MONTGOMERY COLLEGE - OFFICE OF PROCUREMENT
MACKLIN TOWER MBI FINANCE LAB SUITE 100, ROCKVILLE CAMPUS
RFP NO.: 620-011
RFP CLOSING DATE AND TIME: APRIL 7, 2020 @ 3:00 PM

ADDENDUM #1
Issued: March 27, 2020

Project:	MC RV MT MBI FINANCE LAB SUITE 100 RENOVATIONS	Date:	03/25/2020
		Reference:	
Title:	Addendum #1 Drawing Narrative	BKM Project No:	19106.01

3 Section 2
 1/4" = 1'-0" REFERRED FROM:A401

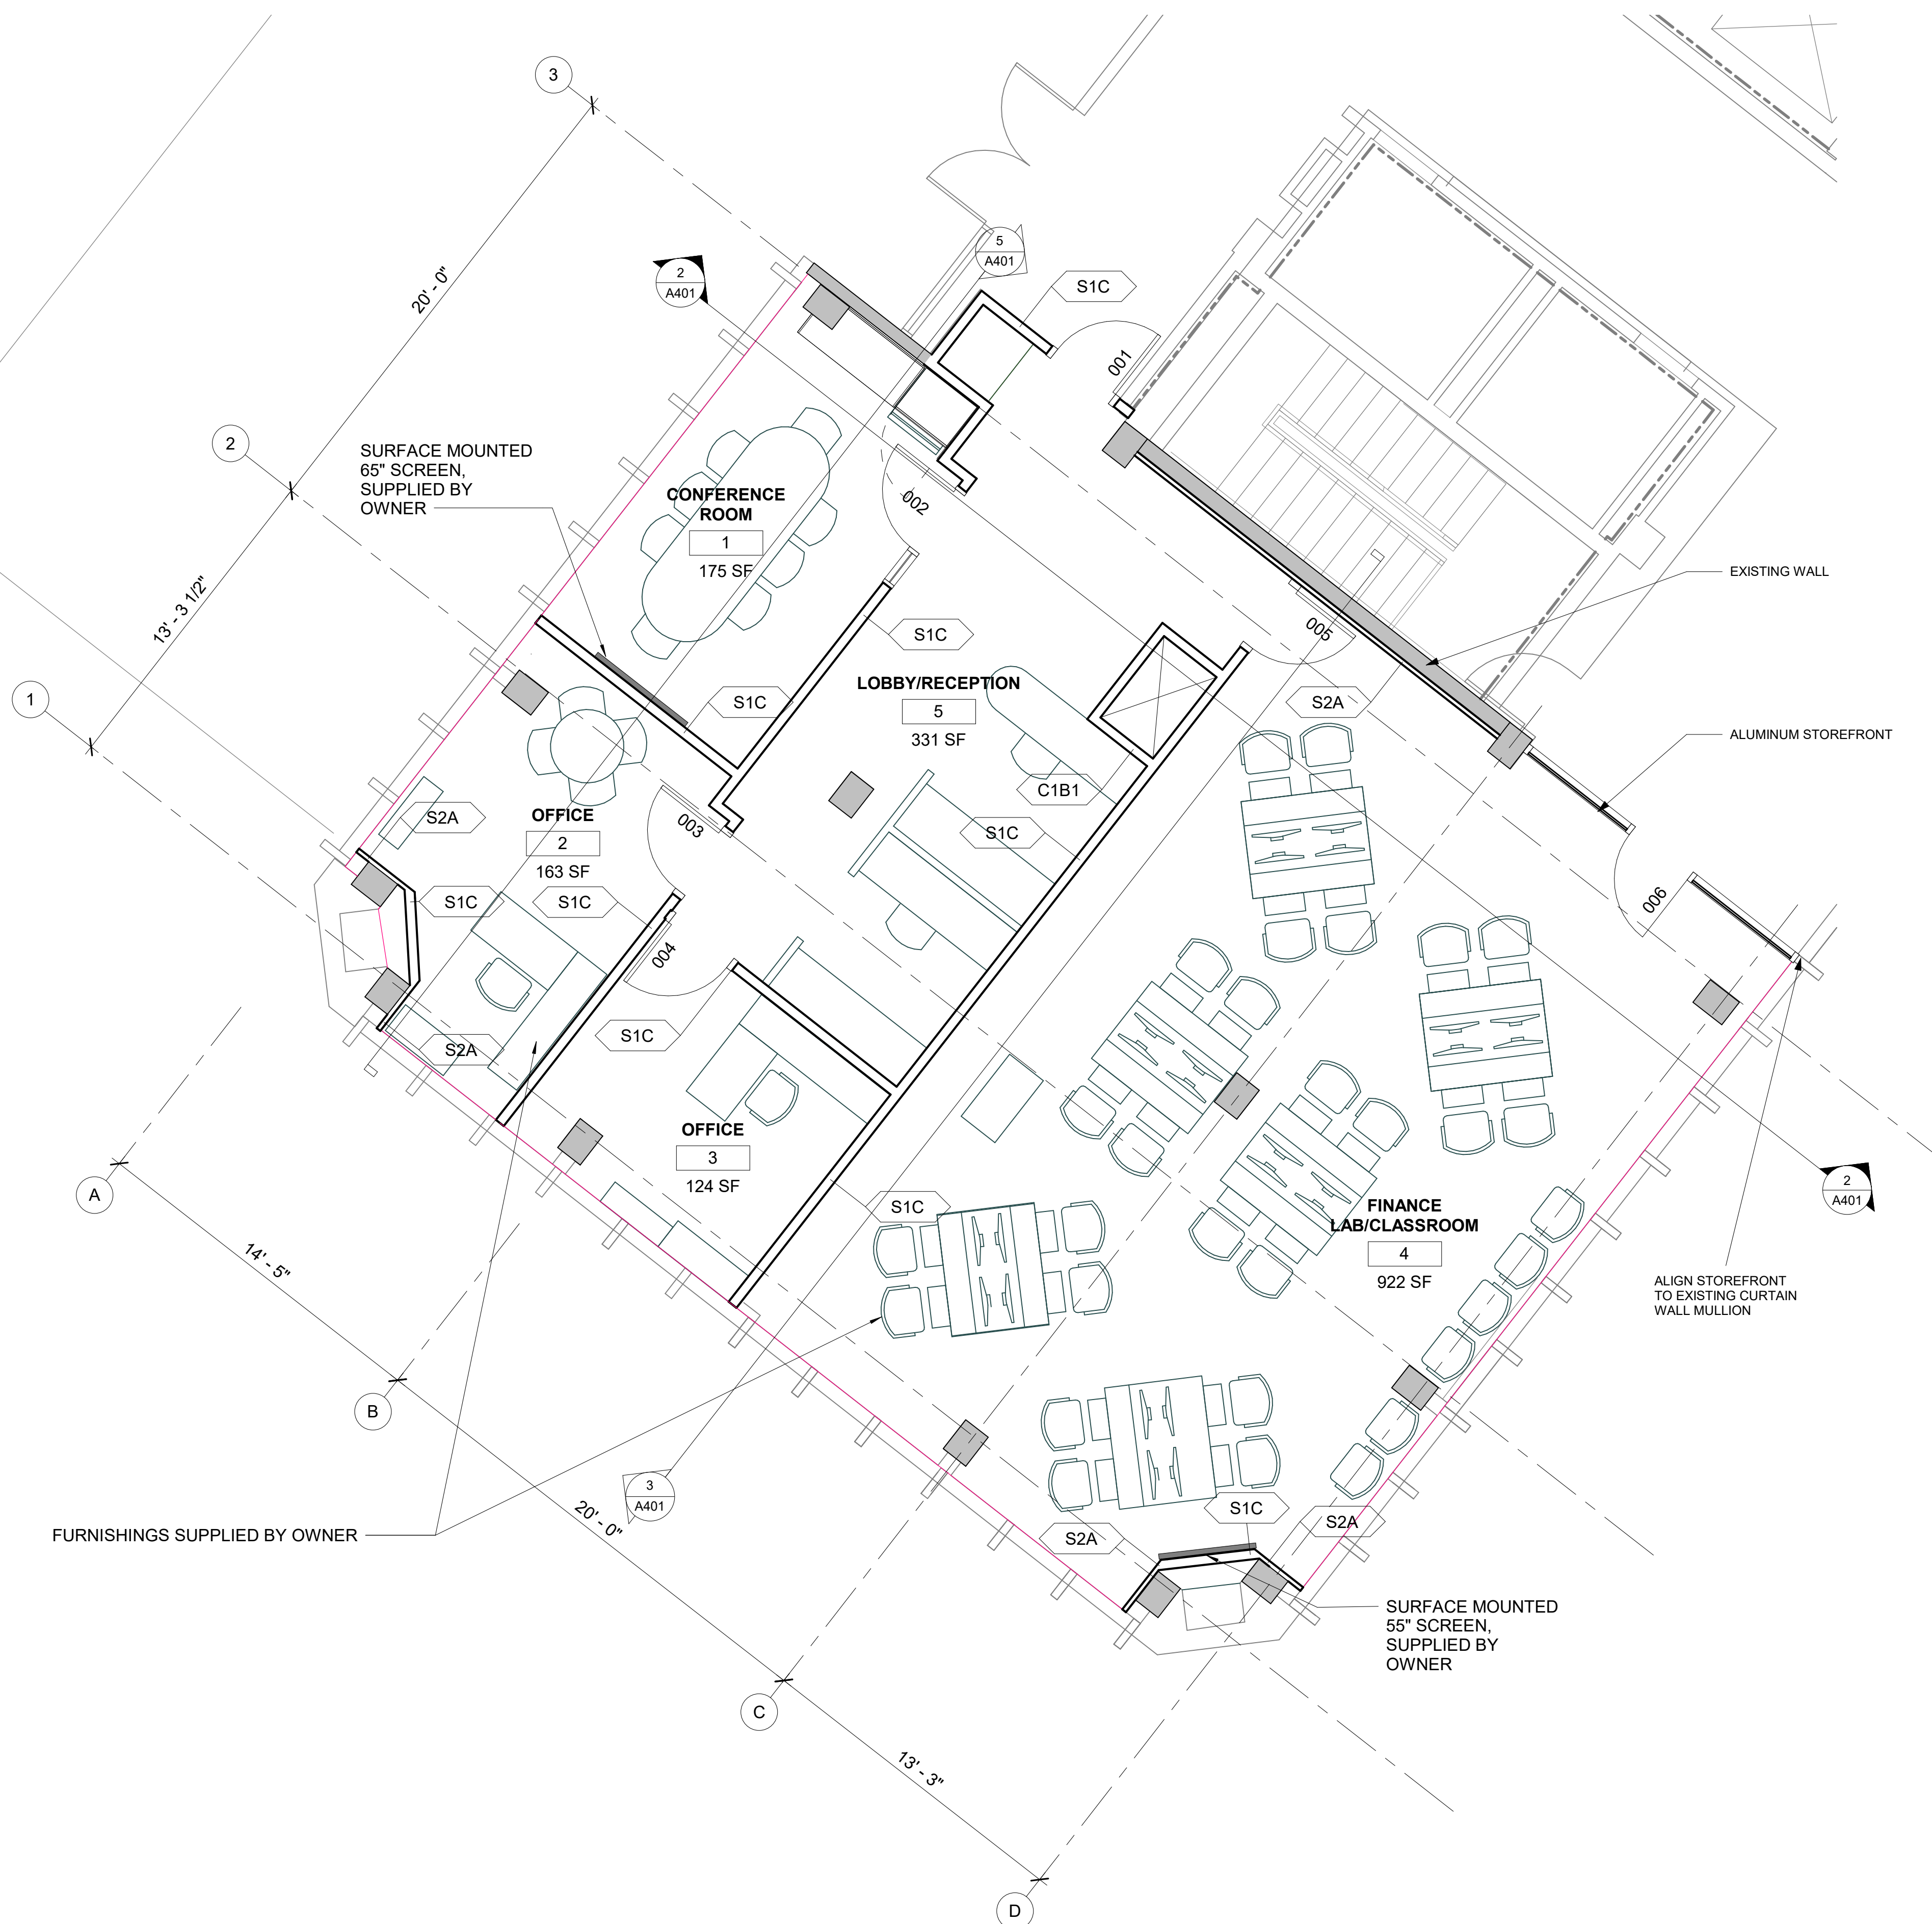
A4.01 – Enlarged Plans and Elevations

- Enlarge Plan and Elevations have been revised.

6 TRANSITION DETAIL - GWB SOFFIT
 3" = 1'-0" REFERRED FROM:

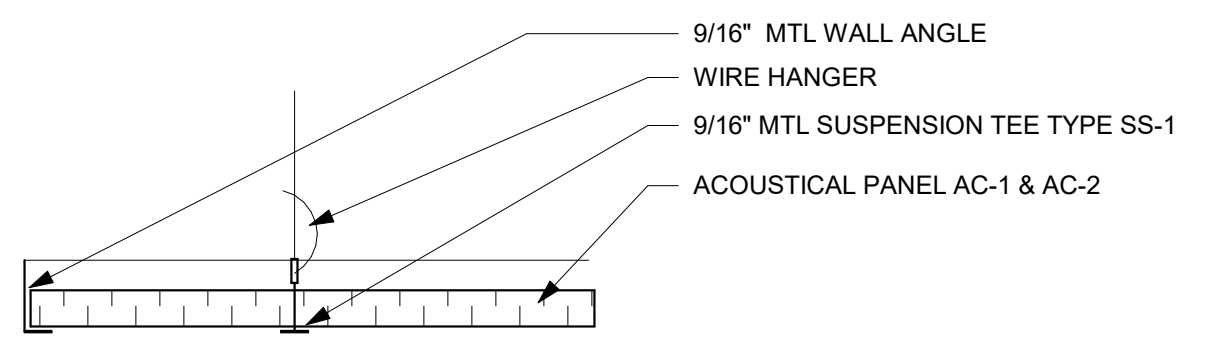
- Detail #6 – Transition Detail has been added.

SHEET TITLE: GROUND FLOOR PLAN
 DUCTWORK
 NEW WORK

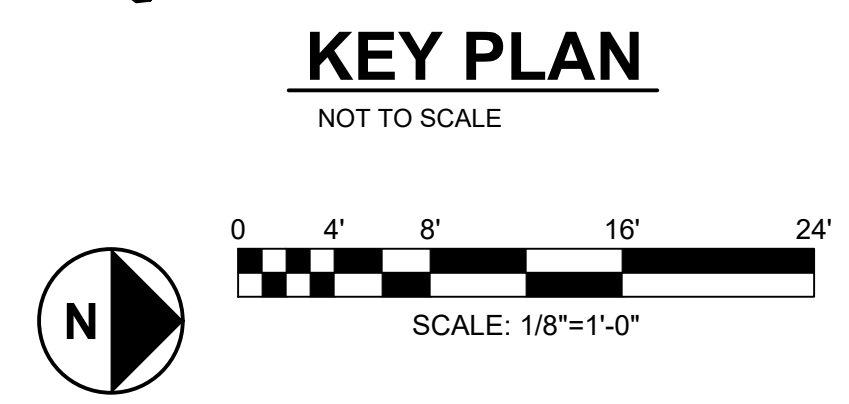
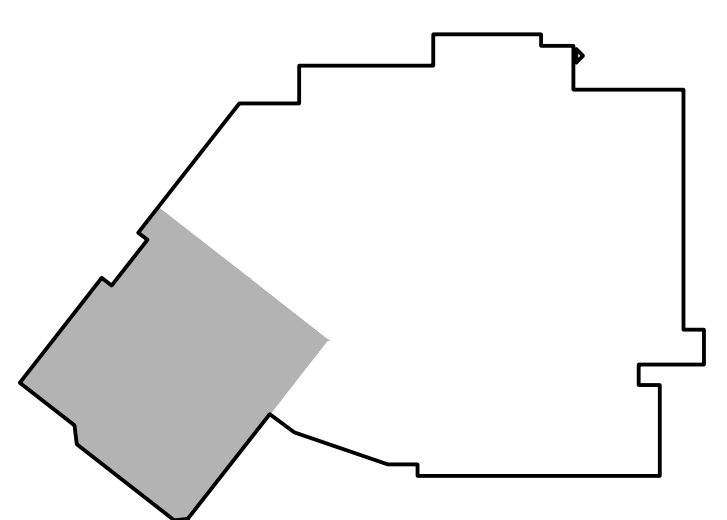
M2.01 “Ground Floor Plan – Mechanical – New Work”

- The relief air louver and associated ductwork has been moved to accommodate future conduit penetrations.
- Temporary heating and cooling requirements have been indicated on the drawing.

- 74"x24" OPEN ENDED RETURN AIR DUCTWORK WITH 1/2" ALUMINUM WIRE MECH SCREEN.
- 96"x24" RELIEF AIR LOUVER THROUGH WALL. PROVIDE RUSKIN L375D STATIONARY LOUVER WITH BIRD AND INSECT SCREEN. PROVIDE LOUVER WITH MINIMUM 45% FREE AREA. COORDINATE FINAL LOUVER COLOR WITH ARCHITECT.

- ROUTE NEW RETURN AIR DUCTWORK TIGHT TO STRUCTURE OVER EXISTING HVAC AND DOMESTIC WATER PIPING.
- CONTRACTOR SHALL PROVIDE TEMPORARY HEATING AND COOLING UNIT(S) TO SERVE MBI SUITE ABOVE AS REQUIRED. SEE GENERAL NOTES ON M0.01 FOR ADDITIONAL REQUIREMENTS. PROVIDE TEMPORARY FLEXIBLE DUCTWORK TO SERVE 28x18 SUPPLY AIR DUCTWORK AND 30x18 RETURN AIR DUCTWORK UP TO MBI SUITE. EXTEND TEMPORARY FLEXIBLE DUCTWORK TO 60x16 RELIEF AIR DUCTWORK TO PROVIDE TEMPORARY VENTILATION UNTIL INSTALLATION OF AHU-9 IS COMPLETE.

SHEET TITLE: FIRST FLOOR PLAN
 MECHANICAL
 NEW WORK

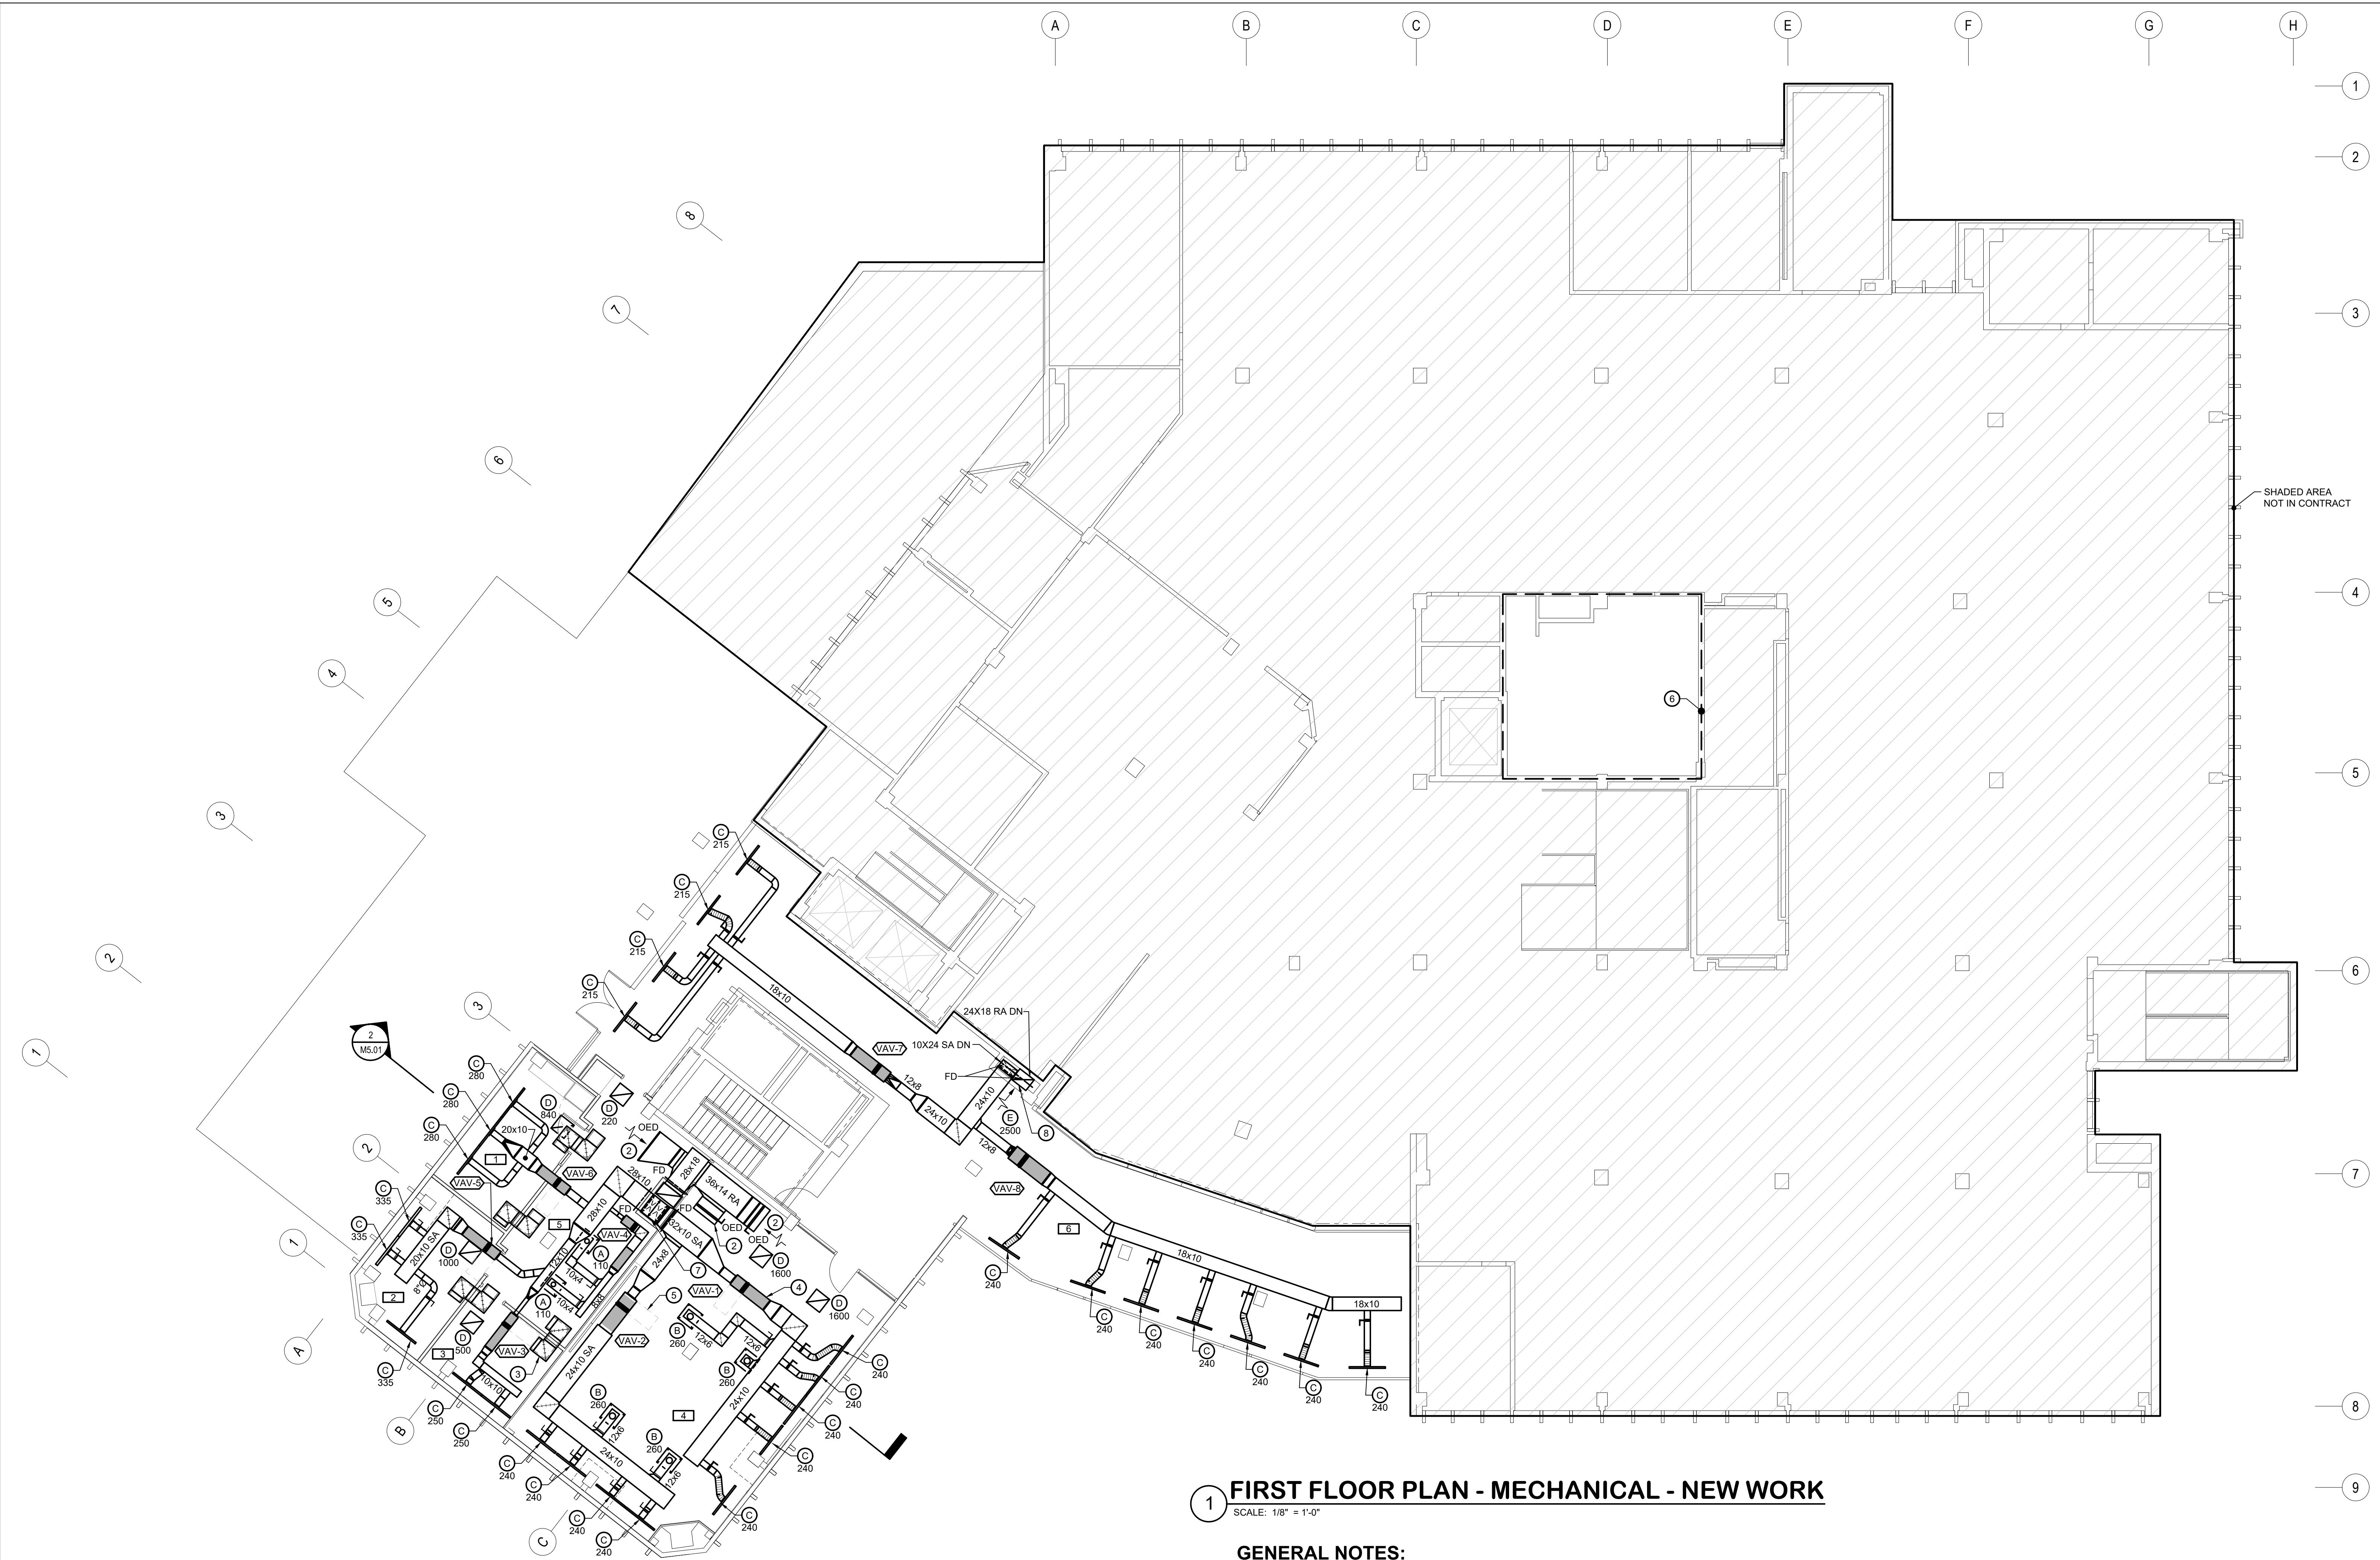
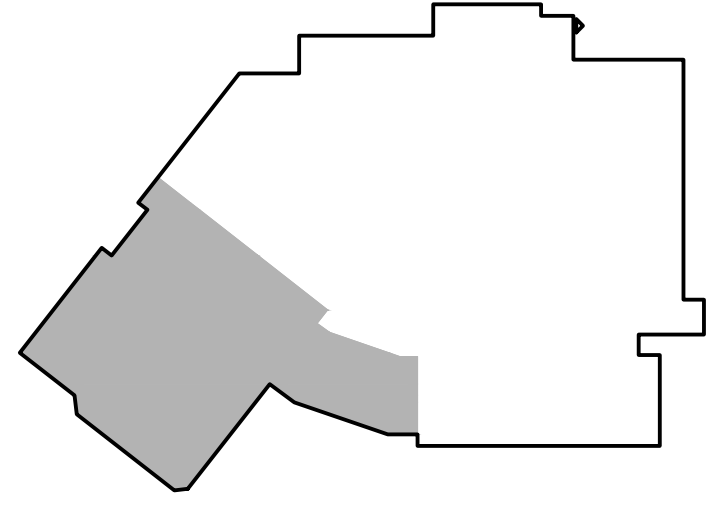
M2.02 “First Floor Plan – Mechanical– New Work”

- Fire protection requirements in “General Notes” have been updated.
- Temporary heating and cooling requirements have been indicated on the drawing.
